86-102 CROSS STREET

CITY OF PORTLAND, MAINE
DEPARTMENT OF BUILDING INSPECTION

Slab for 1,000 gal. Cap.

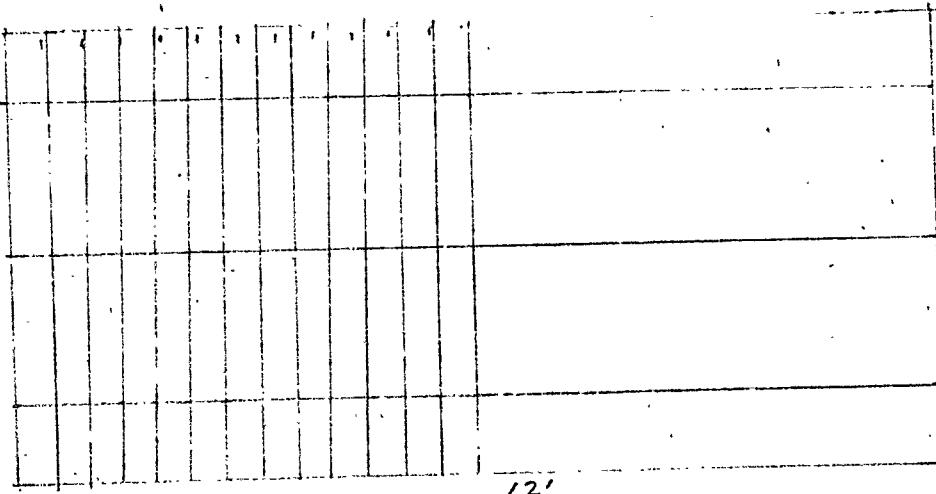
Material - Cement slab of three inches, reinforced with 3/8 square steel rod, as shown in drawing, to be of 150 lb. live weight per square foot as approved by Megquier & Eng.

8 squares 5 1/8 inches on center to 6
Reinforced with 3/8" steel wire
